City of KELLER

Item H-1

PUBLIC HEARING: Consider an ordinance approving a Specific Use Permit (SUP) for an approximately 4,272 square foot detached accessory dwelling unit before constructing a new home, located on approximately 3.57-acres, on the north side of Simmons Drive, approximately one thousand four hundred feet (1,400') east of the Simmons Drive and Rufe Snow Drive intersection, at 1021 Simmons Drive, being Lot 13R, Block 1, Rolling Oaks Estates, and zoned SF-36 (Single Family Residential — 36,000 square foot minimum). Trent and Mary Petty, owners. Greg Wright, Providential Land Development, LP, applicant. (SUP-17-0020)

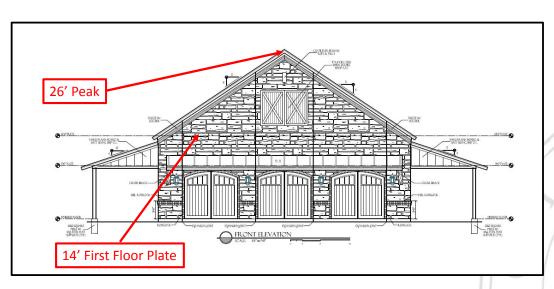
Section 8.10 (A.1) states that the combined area of all accessory buildings on a lot shall be less than fifty percent (50%) of the main structure, unless approved by a SUP

2. Allow combined square footage of all accessory buildings to exceed fifty percent (50%) of the square footage of the primary structure

- 2. A condition for the combined square footage of all accessory buildings to exceed fifty percent (50%) of the square footage of the primary structure to be considered.

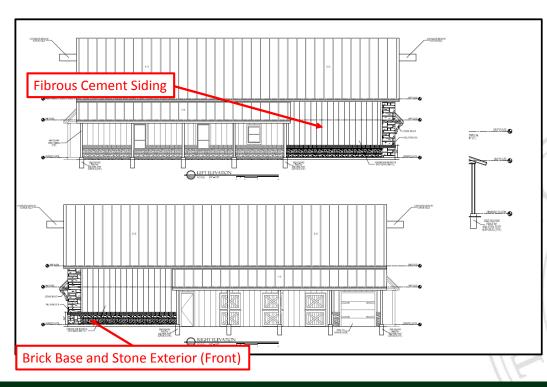
UDC Section 8.10 (A.9) states that the average maximum height for an accessory building is fifteen feet (15') unless approved by a Specific Use Permit.

Average building height is 20'.

A variance to allow the building height to exceed fifteen feet (15').

- 3. A variance for the accessory dwelling unit to exceed fifteen feet (15') in height shall be allowed.
- 4. A variance to waive the eight percent (80%) masonry requirement on the exterior of the accessory dwelling unit as shown in "Exhibit A" shall be allowed.

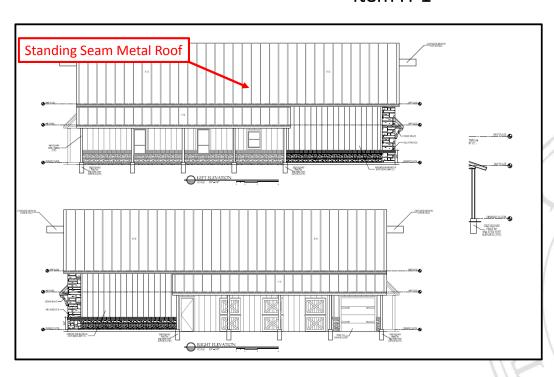
UDC Section 8.10 (A.3) states that accessory buildings shall be complementary to the main structure, constructed of brick or stone or of the same material as the main structure.

- (100%) of the front elevation will be stone with a brick trim.
- The sides and rear have threefoot (3') high brick base with the remainder a fibrous cement siding.
- 4. A variance to waive the eighty percent (80%) masonry requirement as shown in "Exhibit A."

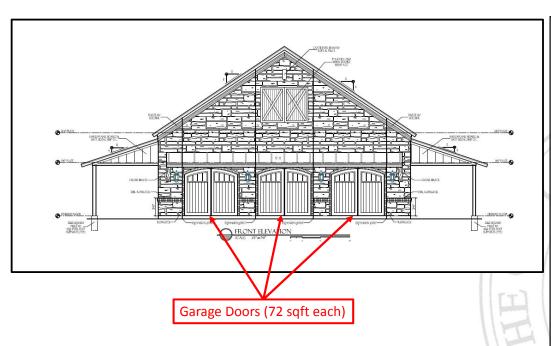
UDC Section 8.10 (A.3) states that accessory buildings shall be complementary to the main structure, constructed of brick or stone or of the same material as the main structure.

- House roof is shingle, proposed roof is standing seam metal.
- 5. A variance to allow the roof material to be metal.

- 5. A variance for the accessory dwelling unit to have a metal roof shall be allowed.
- 6. A variance for the front-facing garage door exposure to exceed one hundred forty-four (144) square feet, up to two hundred sixteen (216) square feet shall be allowed.
